Planning Commission Staff Report

Subject: Green Park Cohousing
Authors: Francisco Astorga, Planner
Anya Grahn, Historic Preservation Planner
Project Number(s): PL-13-01831
Date: February 12, 2014
Type of Item: Administrative - Conditional Use Permit Application

green park cohousing park avenue

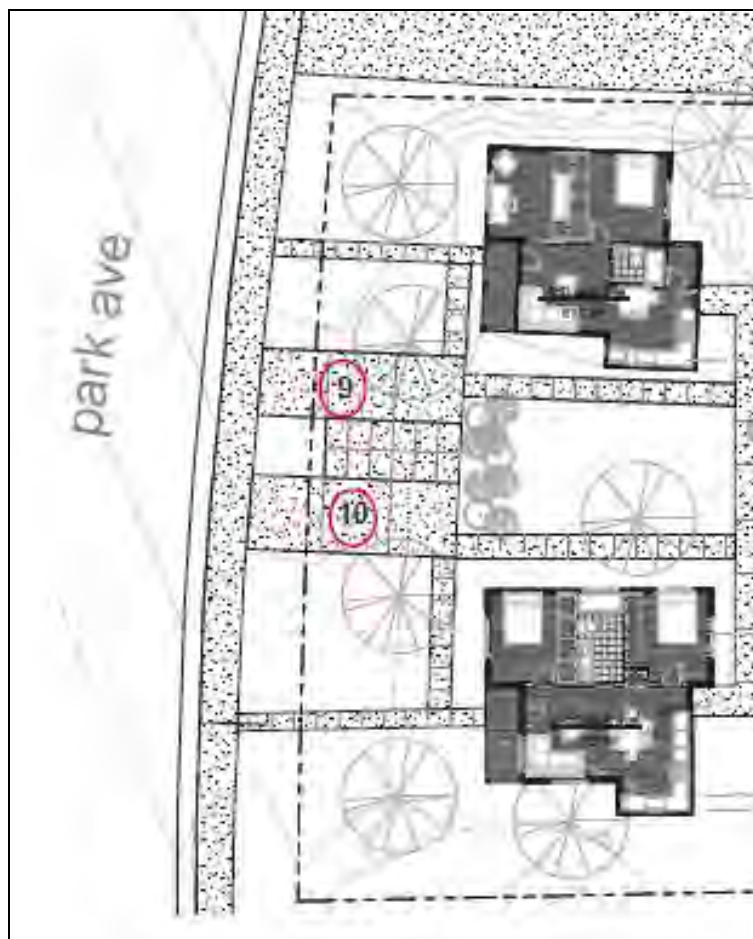
The applicant intends to provide six (6) garage parking spaces at the rear of the property, facing Sullivan Road. An additional two (2) parking spaces are requested adjacent to the driveways leading to the garages. The two (2) existing Park Avenue parking spaces are to remain.

The applicant has noted that the layout the rear of the site does not contain a parking area of 5 or more parking spaces due to the fact that as shown below, there are six (6) driveways and two (2) parking spaces (parking space no. 1 and no. 2). After careful consideration, including the newest layout shown below, the Planning Department agrees with this assessment; however, it needs to be noted that the City Engineer, does consider this layout a parking area containing 5 or more parking spaces:
